Safety Advisory 2006-03

ACTION: Notice of Safety Advisory; Vertical Load Dividers.

SUMMARY: FRA is issuing Safety Advisory 2006-03, in order to provide interested parties information related to the potential failure of the welded attachment of vertical load dividers on

Drawing of Vertical Load Dividers
on BCOL Center Beam Flat Cars
Highlighting Area of Weld Breaks at
Base of Divider Beams

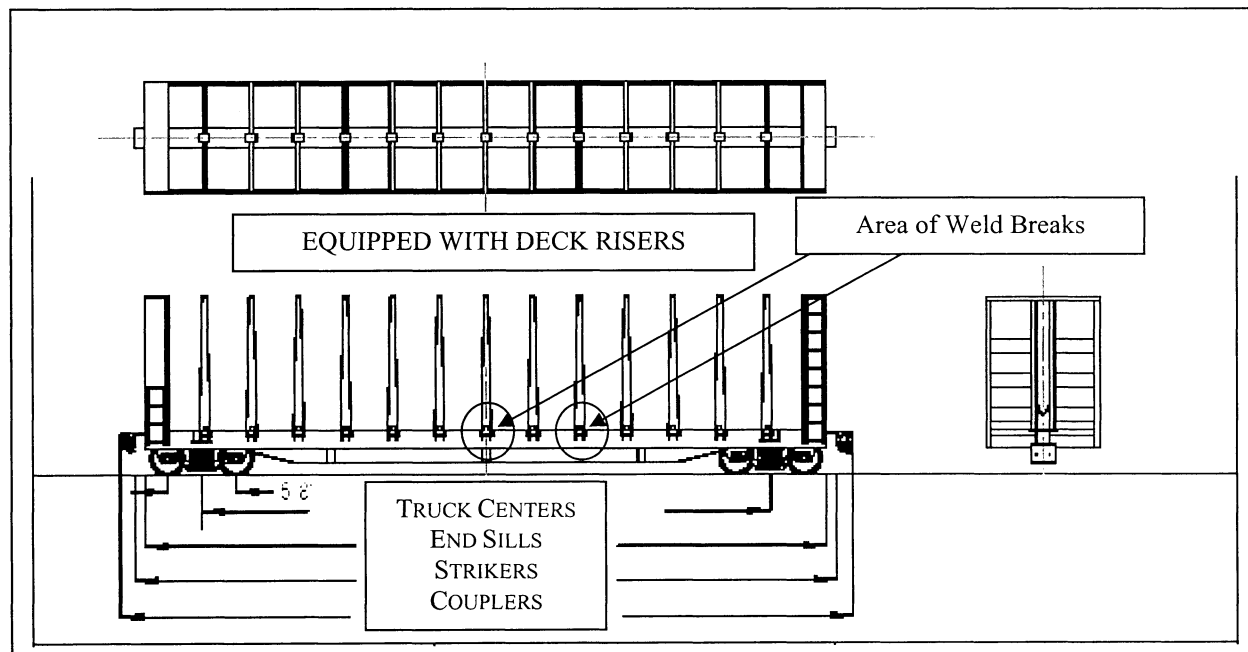
SUPPLEMENTARY INFORMATION: FRA was recently made aware of the weld failure of a vertical load divider on center beam lumber flat car GWRC 52850. The failure occurred while the car was traveling on the main line of the Long Island Railroad. One of the vertical load divider beams detached (broke away) at its base from the main car body and came to rest on a Long Island Railroad passenger station platform (See Figure 1). This incident occurred on August 31, 2005, and resulted in no injuries. A post accident analysis of the weld attachment of the vertical load divider beam revealed poor and insufficient weld of the vertical load divider beams at time of original car construction. The involved car is one of five (5) center beam lumber flat cars owned by the Georgia Woodlands Railroad Company. As a result of this incident, Georgia Woodlands Railroad Company had the vertical load divider beams on all five of its cars re-welded and reinforced with support gussets to prevent the dividers from breaking in the area of the original weld.

Recommended Action: In recognition of the need to assure safety, FRA recommends that railroads and car owners carefully inspect the welded attachment of the vertical load divider on center beam lumber flat cars. The best inspection of the welded attachment would include the use of a dye penetrant type procedure to thoroughly detect weld cracks. FRA further recommends that cars found with poor or defective welds be repaired

by using new welds and gussets in accordance with good quality control shop practices.
